RECEIPT DATE: 7/20/17 **ONSITE SEWAGE DISPOSAL SYSTEM**

SEPTIC PLAN
COUNTRY SPRINGS
 LOT 19
 15046 SCOTTSDOOD COURT

RE: 15046 Scottswood Ct.
Woodbine, MD 21797
"OSDS"

Here are my comments for 15046 Scottswood Ct. Onsite Sewage Disposal System Design Plan.

W HO-93-0291

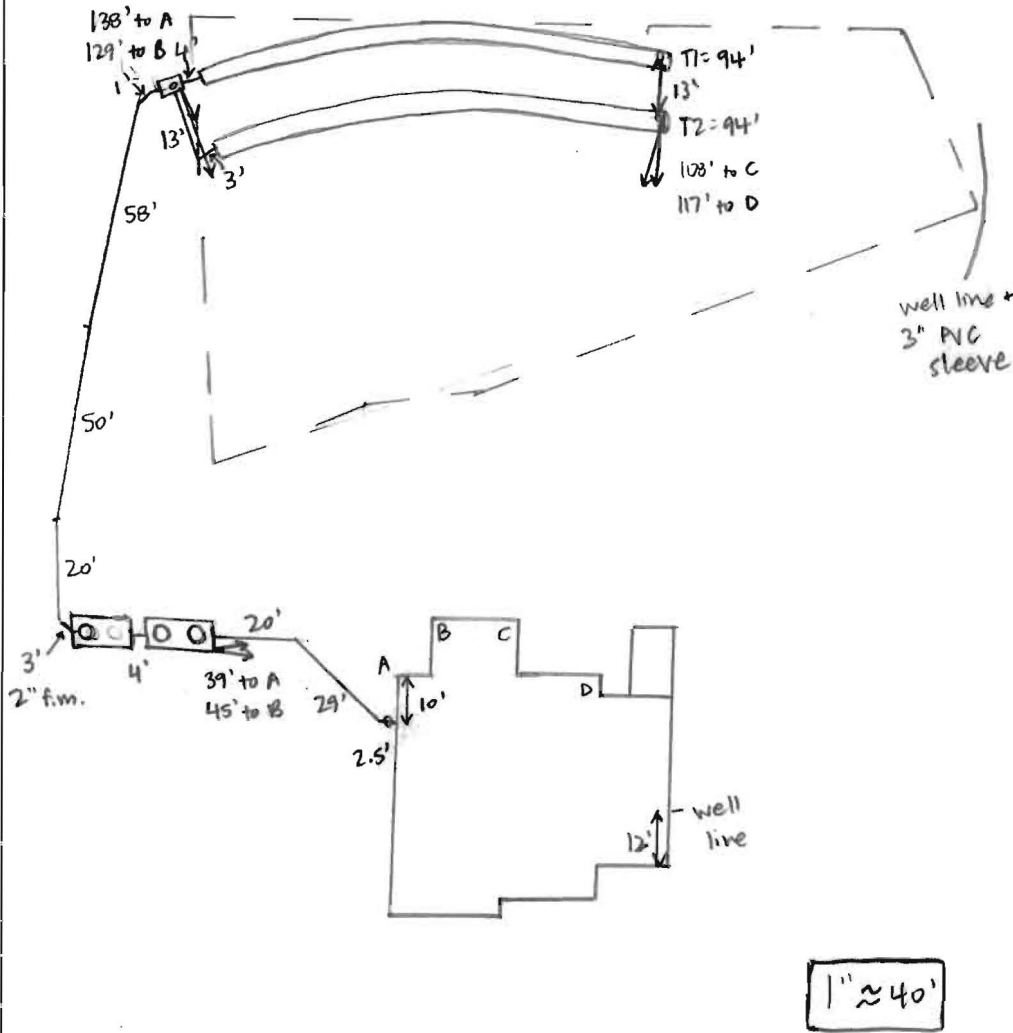
8/2/17 Met S. Carroll on site for layout. All SDA and tank stakes present. Adjusted tank placement to keep even cover over both tanks. Trenches staked - checked elevations at stakes. Trenches staked at 13' center-to-center - moved T2 uphill to keep 13' center-to-center. Well line installed crossing through NE corner of SDA - plumber must move it outside + sleeve when $\leq 10'$ from SDA. (SC)

8/2/17 House connection made. On site while septic tank was set - no cracks on sides or bottom. Also saw pump tank setting, but had to leave before final depth/level was reached. (SC) 8/3/17 T1 complete + left open @ ends for inspection. S. Carroll adding stone to T2. 3' wide, 8' bottom @ T2, T1 3.5' to stone + 3' wide. Pump tank set. Well line now sleeved w/ 3" PVC when $\leq 10'$ within SDA. (SC) 8/9/17 D-box installed + connected to trenches. 2" force main run from pump tank to D-box. Need pump + alarm test. (SC) 9/5/17 Met S. Carroll on site for pump + alarm test. Alarm sounds, pump pumps effluent to D-box. Alarm wire needs to be in conduit - fix + retest alarm. (SC) 9/7/17 Alarm wire in conduit, alarm sounds when triggered. (SC)

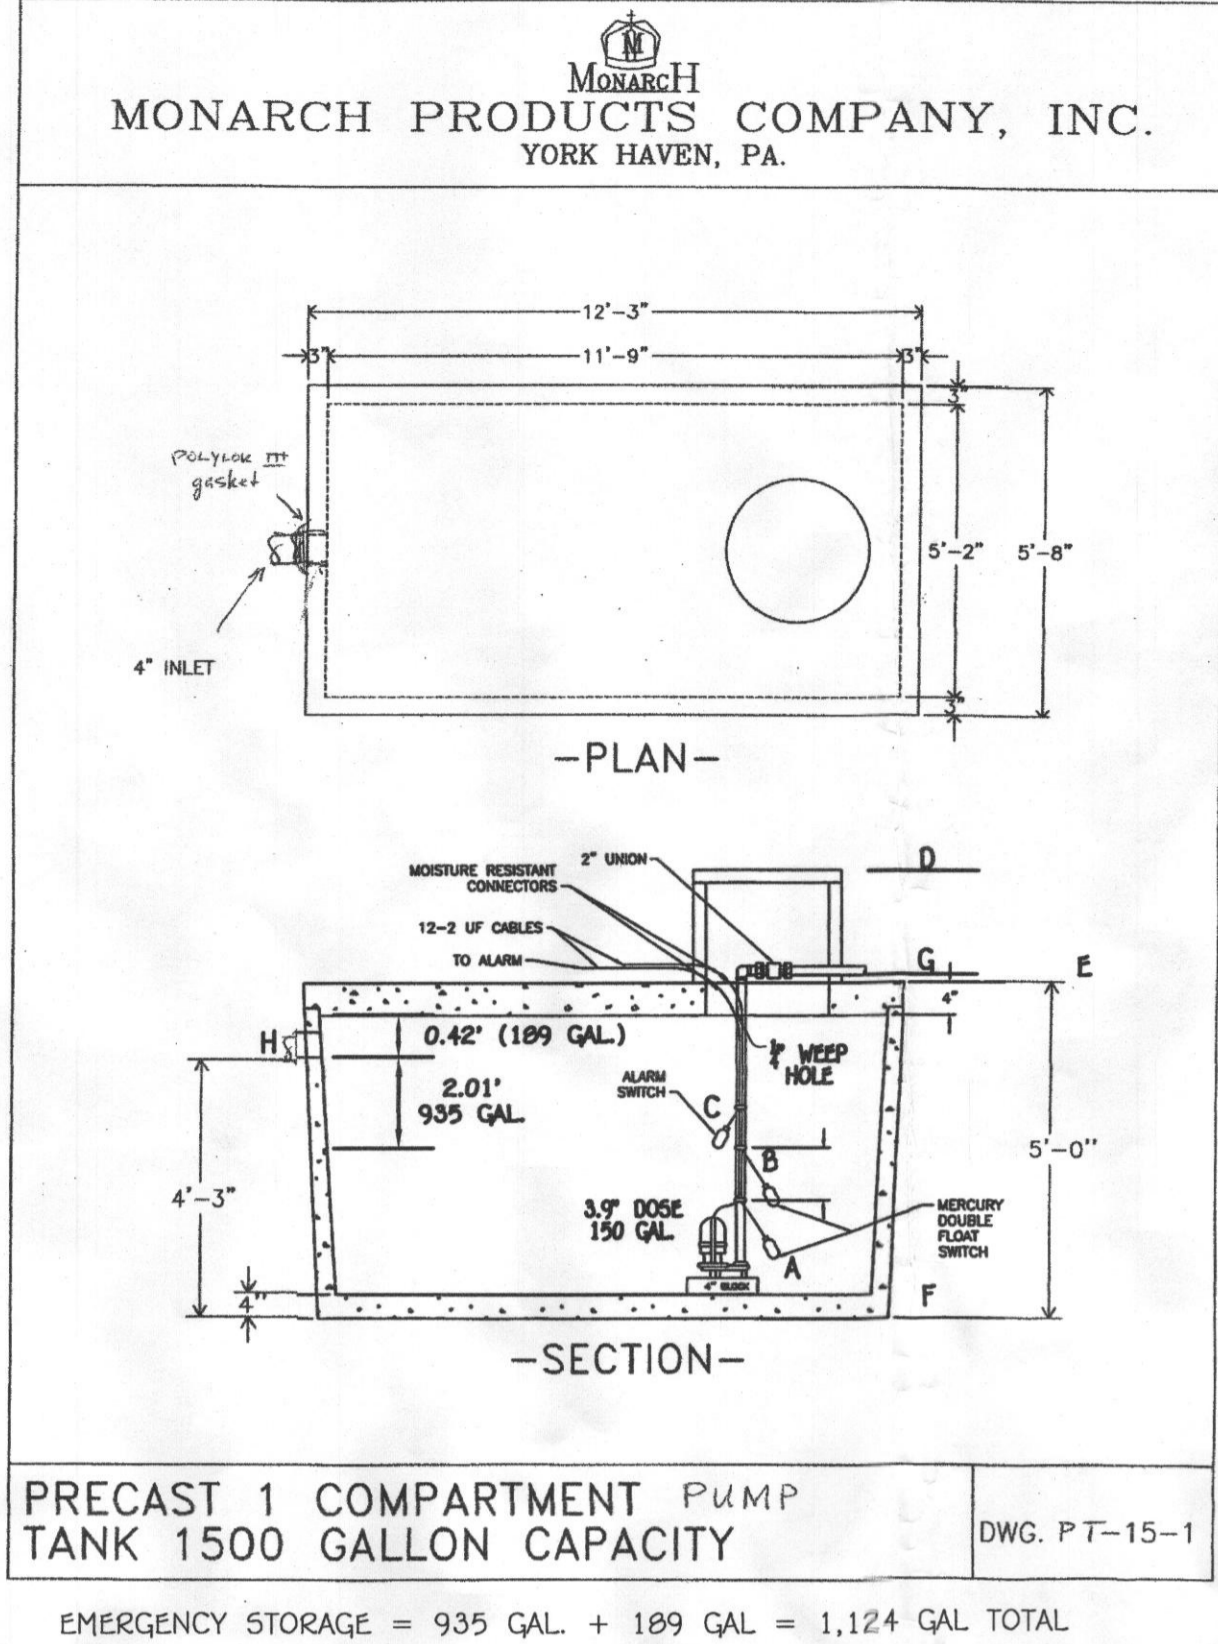
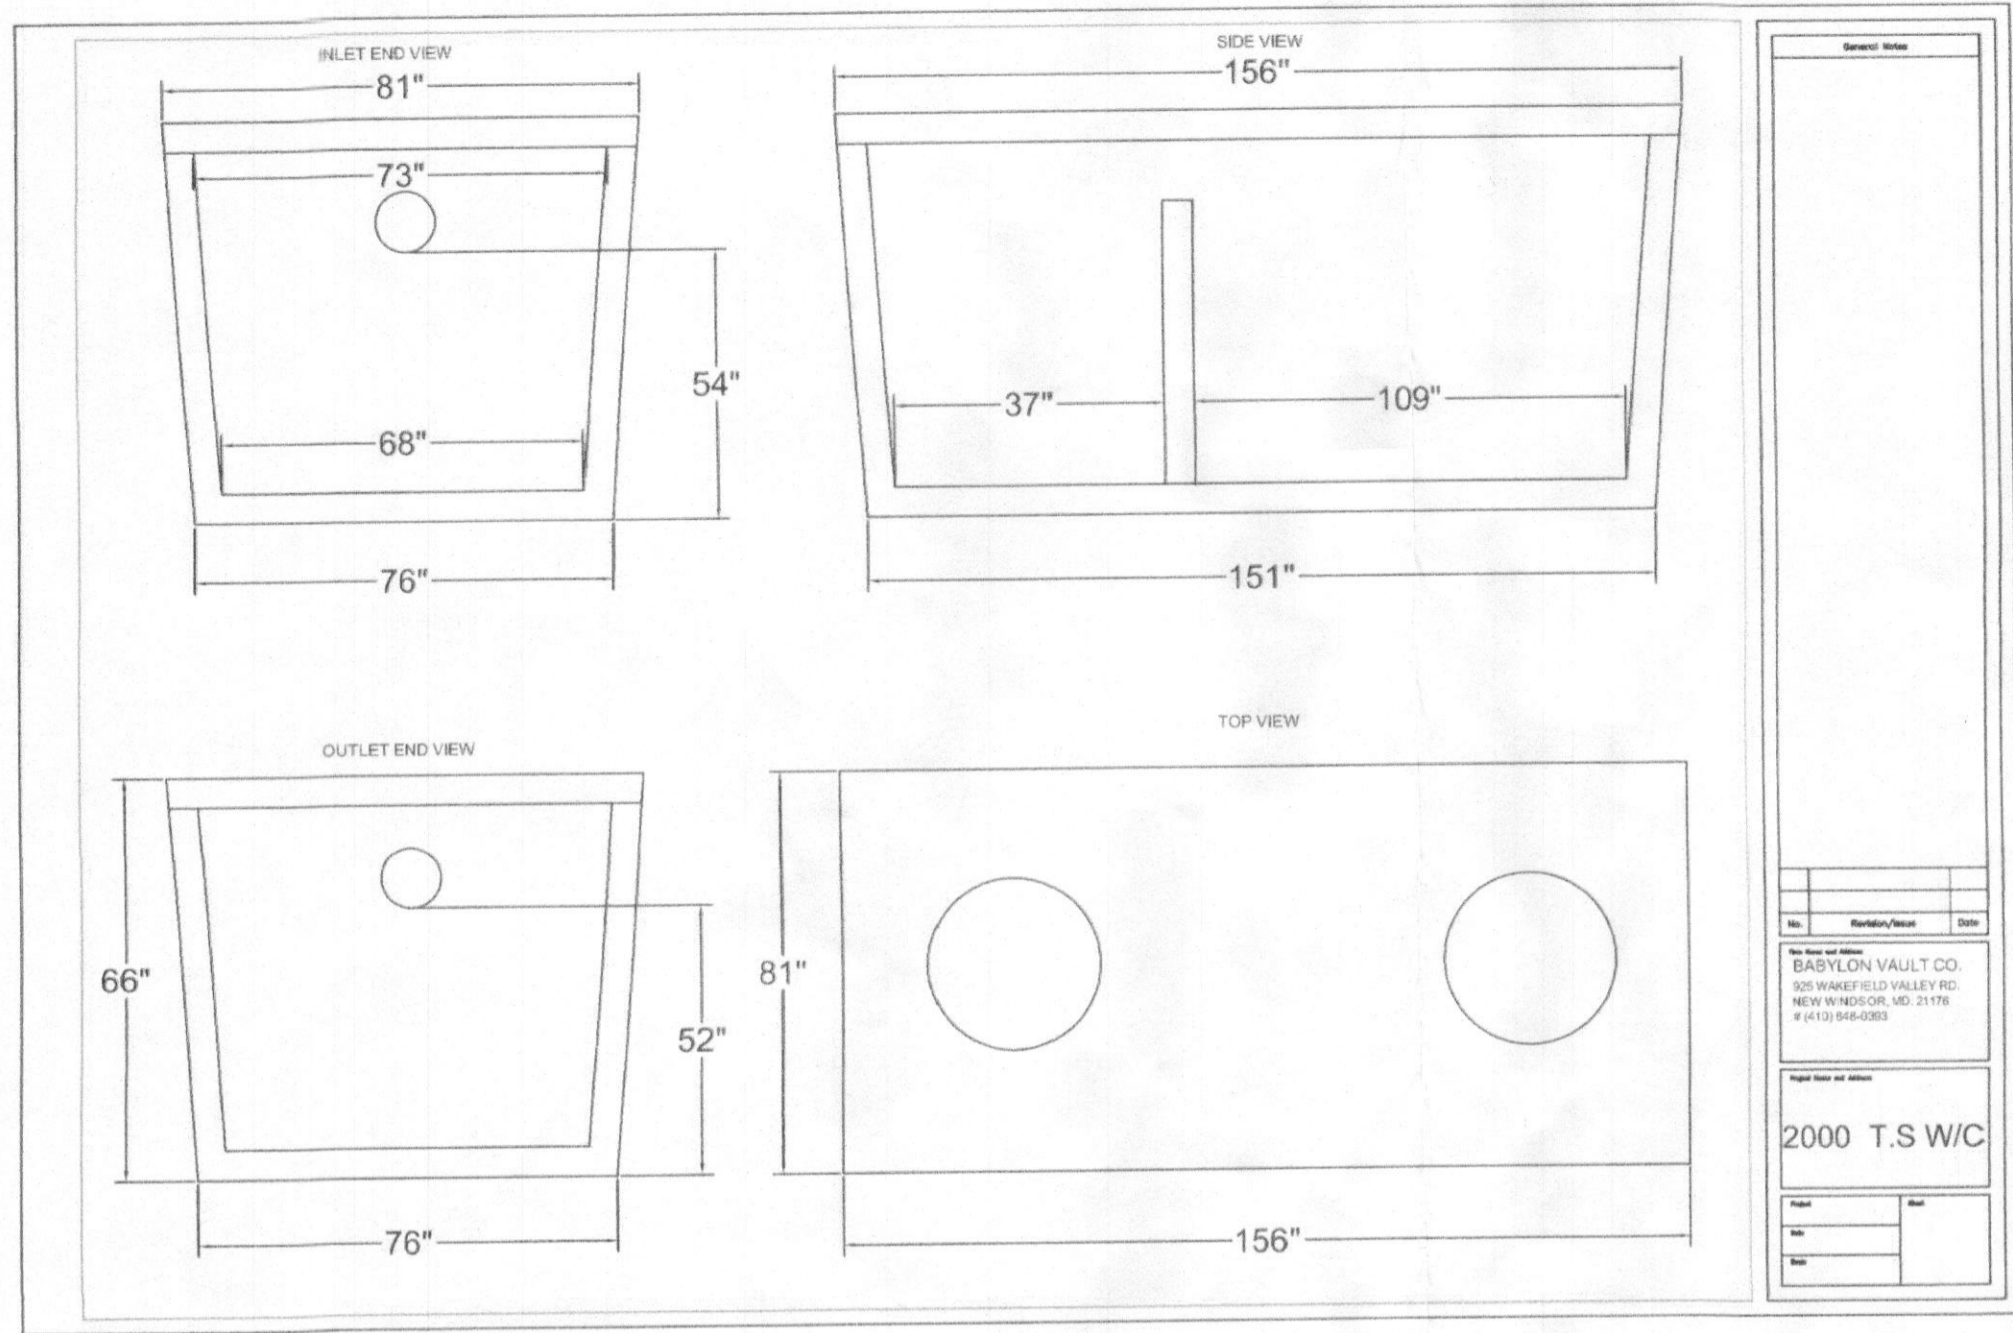
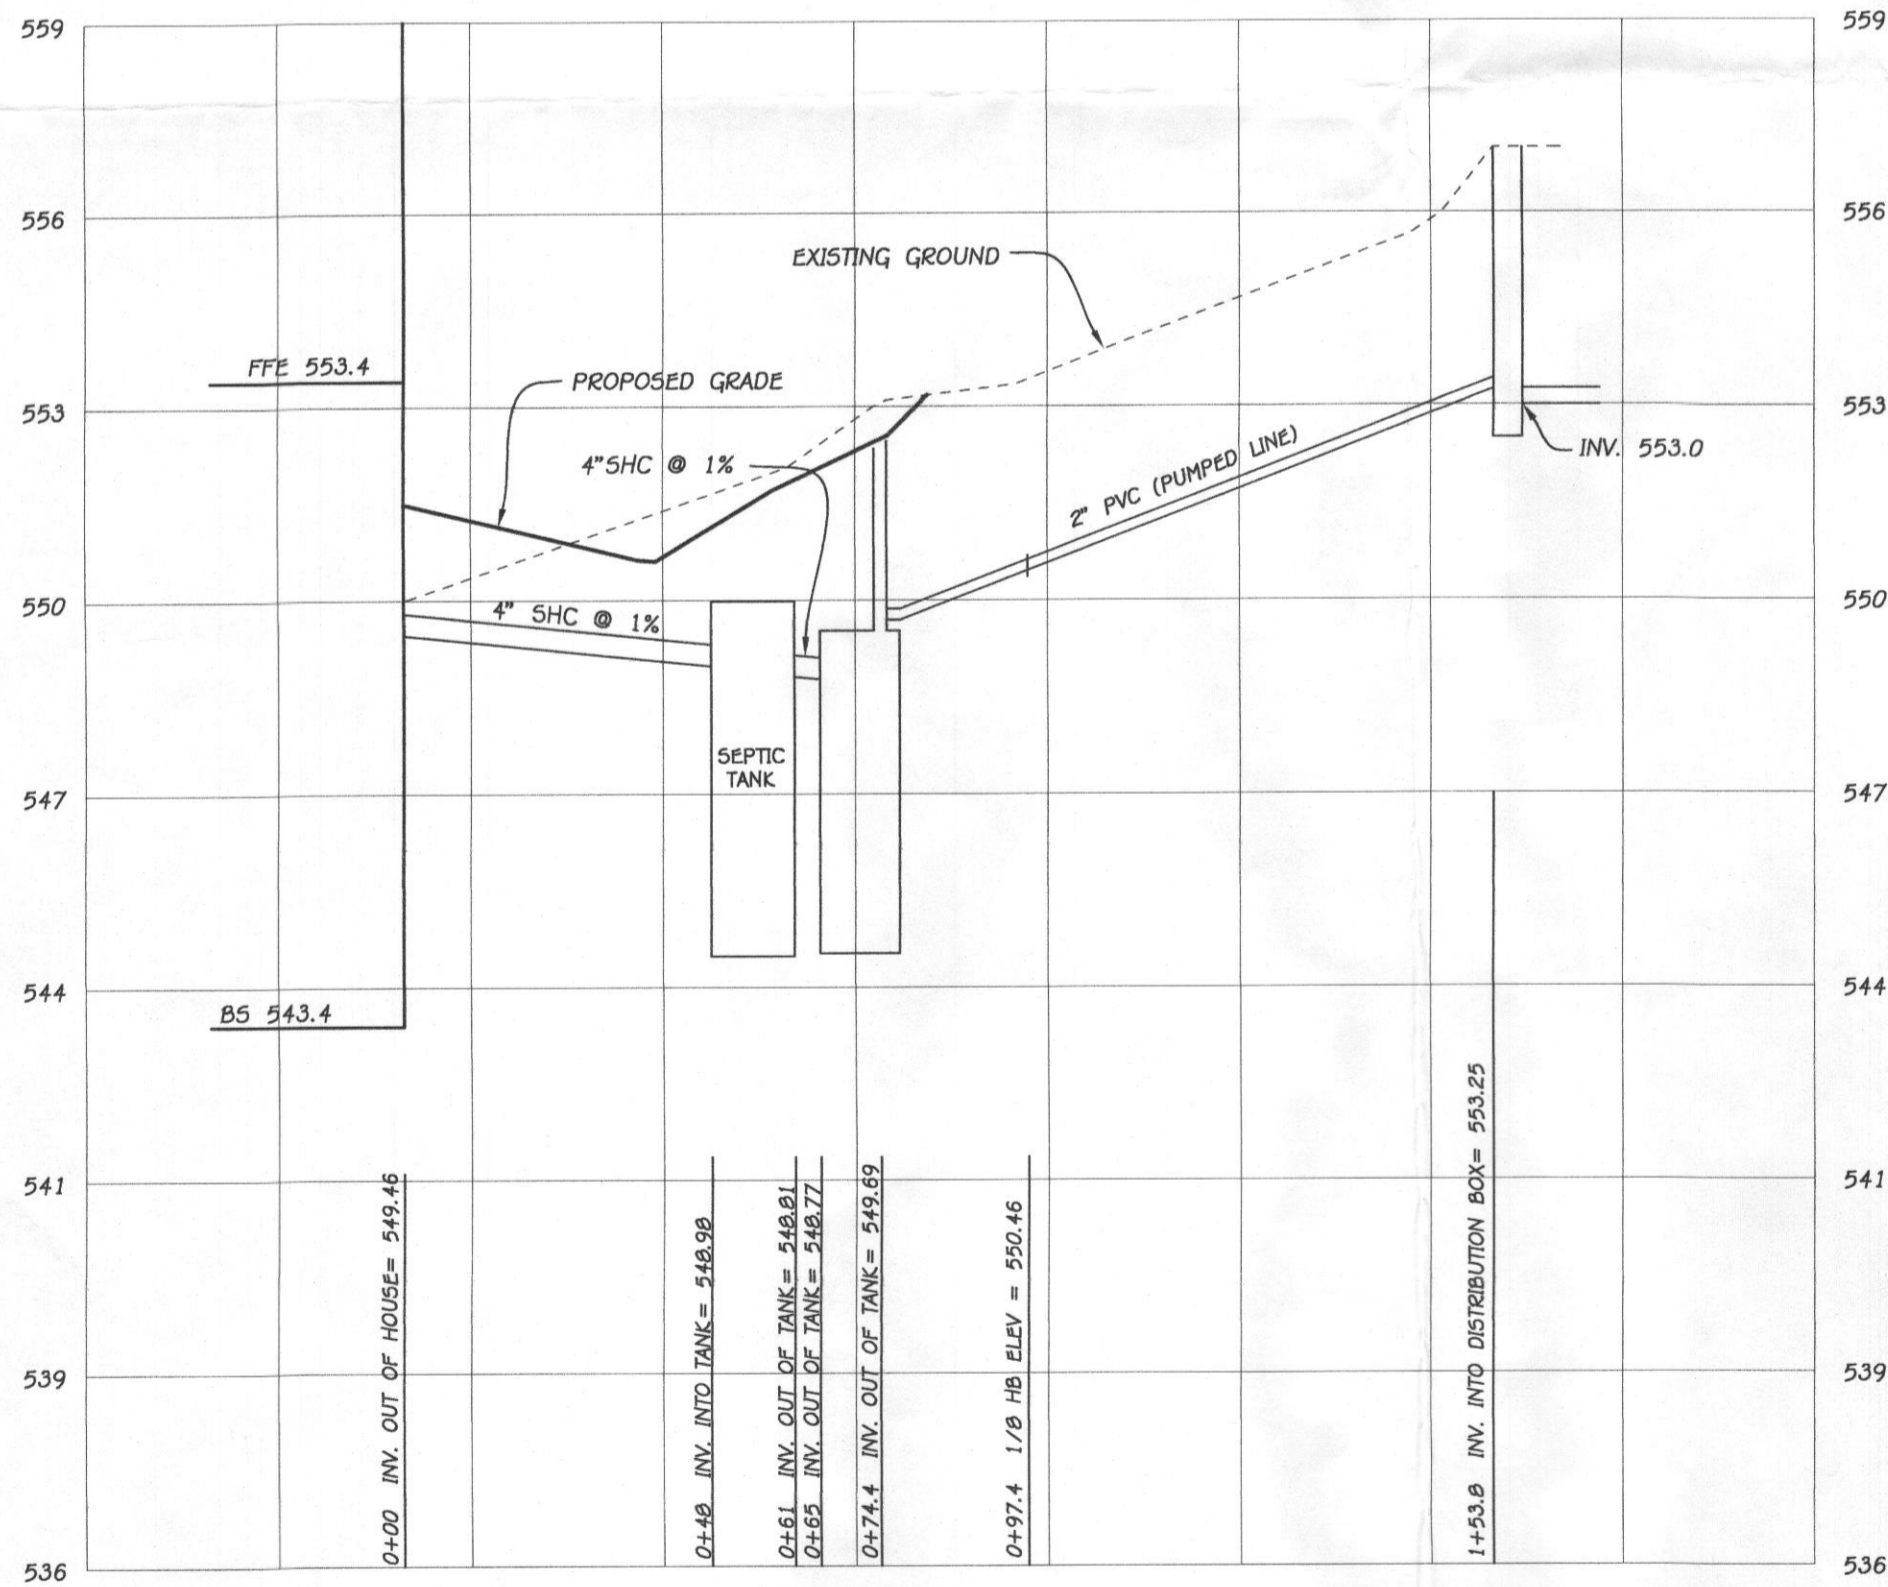
- don't need* x • Two Alternate well sites or a 1500sqft well box must be added to the plan.
- ✓ Replacement trenches need to be shown on the plan.
- ✓ Elevations between the "Septic Profile" and "Septic System Elevations" are not consistent.

- The septic tank/pump tank is unacceptable. The pump must have its own chamber separate from the two compartments of the septic tank.
 - It is recommended the OSDS design include a heavy load bearing septic tank. The 1% fall in conjunction with grading limits room for error with pouring the foundation slab at the planned elevation.

- Not shown* ✓ A 2 inch in height and 4 foot wide slot must be shown in the dividing wall of the two compartments of the septic tank.
- ✓ There needs to be 6 inches between the pump and the tank floor.

- ✓ The septic tank needs to be 25ft from the storm water management dry well.
- ✓ Add the note: "Any change to the locations or depths to any components must be approved by the engineer and the Howard County Health Department prior to installation. A revised site plan may be required."

- ✓ Add the note: "The maximum earth cover over the tank is 3 feet. Greater earth cover will require a heavy load bearing tank." (If not a load bearing septic tank)

- ✓ Add the note: "Electrical work for the installation must be performed by a licensed electrician."
- ✓ Add the note: "The well (tag#) has been field located and is accurately shown."

The septic tank does not need to be a heavy load bearing tank. It is a precautionary recommendation due to the 1% fall, the grading and the possibility the hung sewer hole is drilled by the plumber before reviewing the septic plan or doing the layout. The pump tank is going to need to be a load bearing tank if the grade goes unchanged. I was informed that the 2 inch slot in the dividing wall of the septic tank does not need to be shown. Hope this helps.

the tank is 2.7' in the ground why do I need a load bearing tank. I thought it need to be 3'+ for it needing load bearing.
